REVISED RESPONSE TO REQUEST FOR ADDITIONAL INFORMATION**APR1400 Design Certification****Korea Electric Power Corporation / Korea Hydro & Nuclear Power Co., LTD****Docket No. 52-046**

RAI No.: 255-8285
SRP Section: 03.08.05 – Foundations
Application Section: 03.08.05
Date of RAI Issue: 10/19/2015

Question No. 03.08.05-7

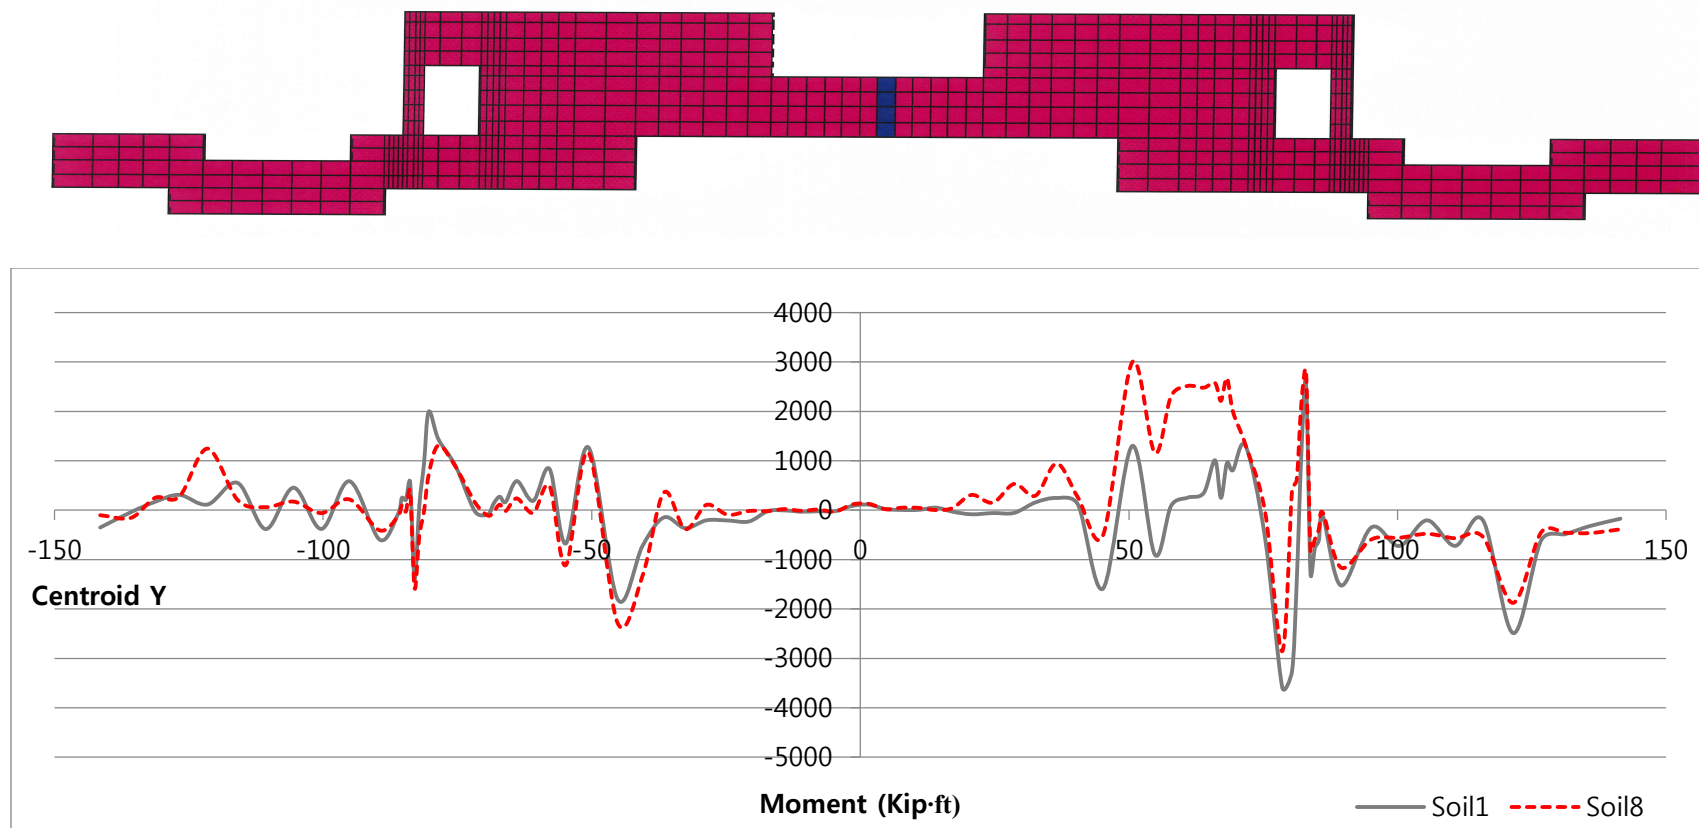
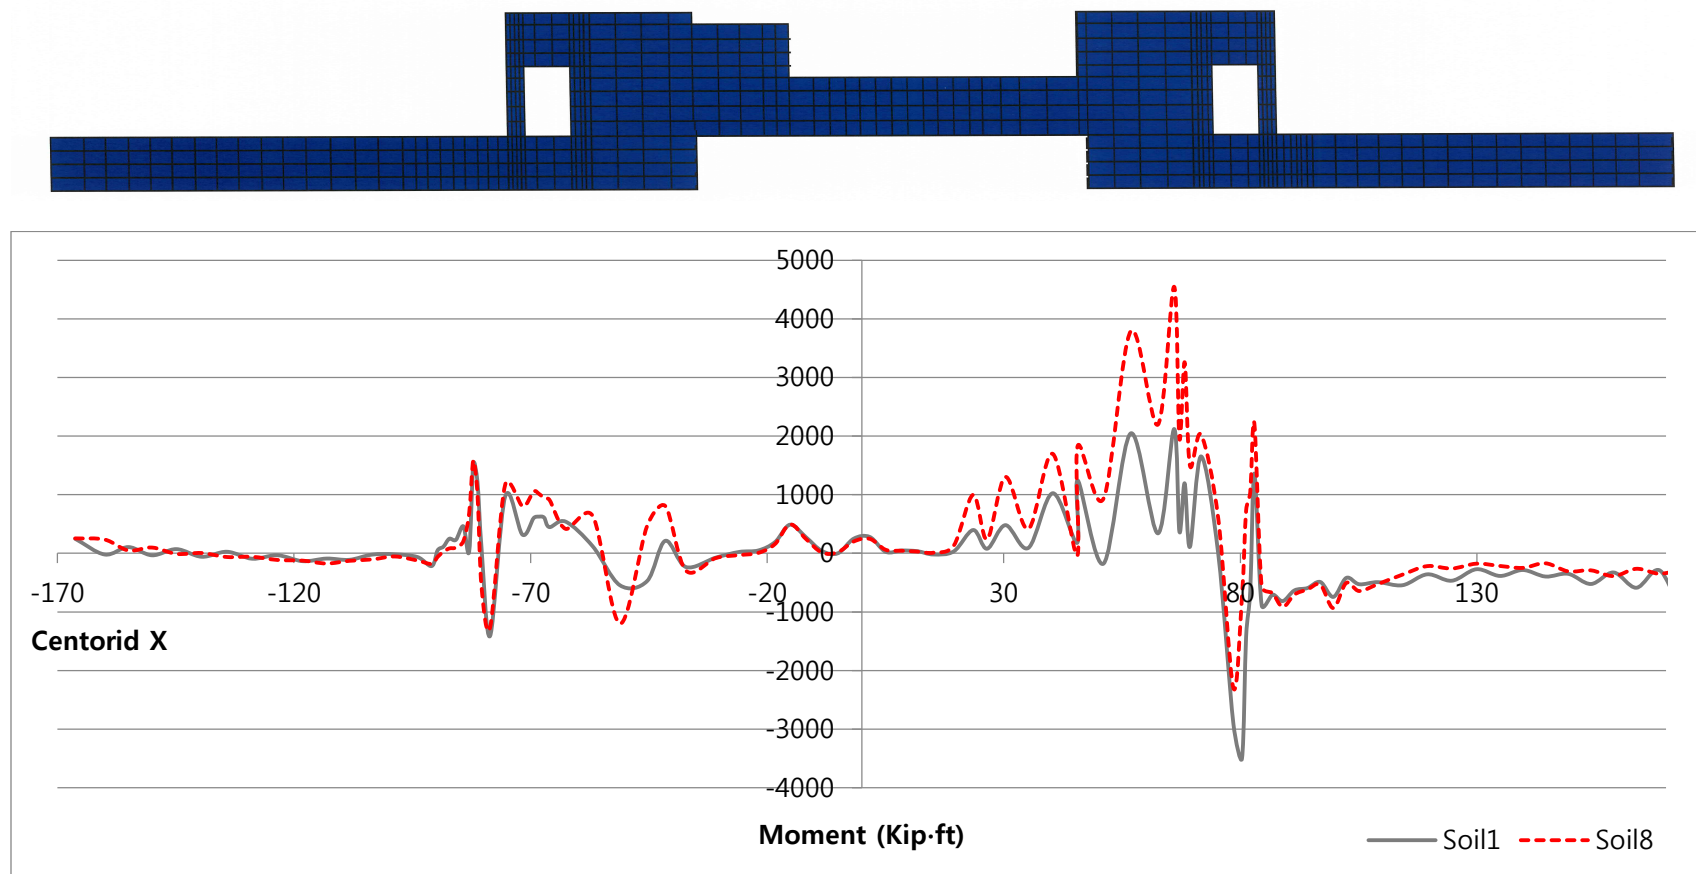
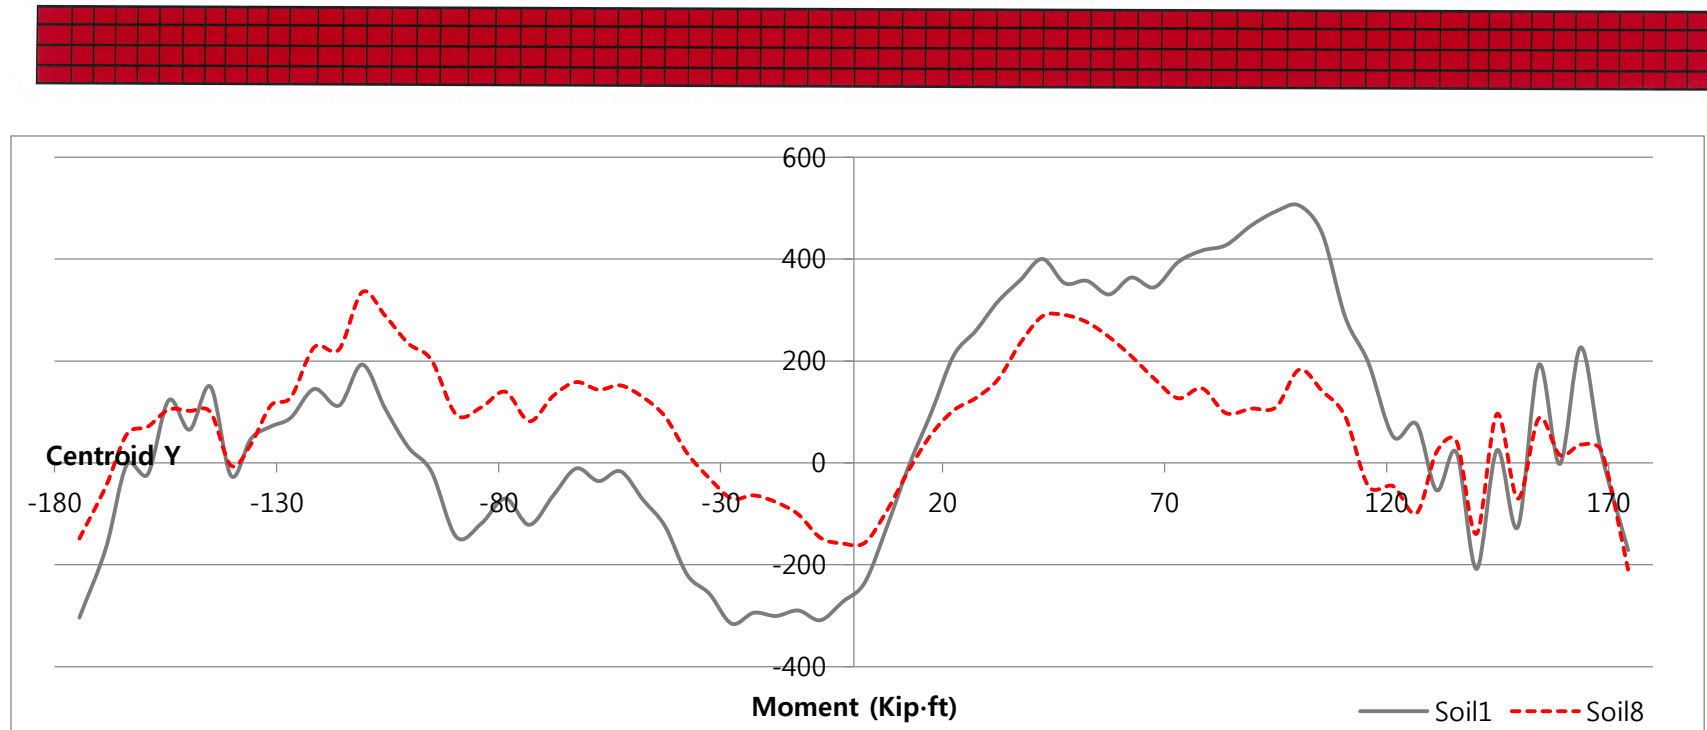
In DCD Tier 2, Section 3.8.6.4, "Design and Analysis Procedures," the applicant stated "The maximum differential settlement of foundation is 12.7 mm per 15.24 m (0.5 in per 50 ft) within NI common basemat. The maximum differential settlement between buildings is 12.7 mm (0.5 in) based on enveloping properties of subsurface materials. " However, it is not clear to the staff how the construction sequence and differential settlement of foundations were considered in the load and load combinations. Therefore, the applicant is requested to describe how the construction sequence and differential settlement of foundations were considered in the load and load combinations. Also, DCD Section 3.8.5 should be updated accordingly.

Based on three figures above (Figures 2 thru 4), it is not clear which soil case condition is governed for the basemat design. Therefore, both soil profiles S1 and S8 are considered for construction sequence analysis.
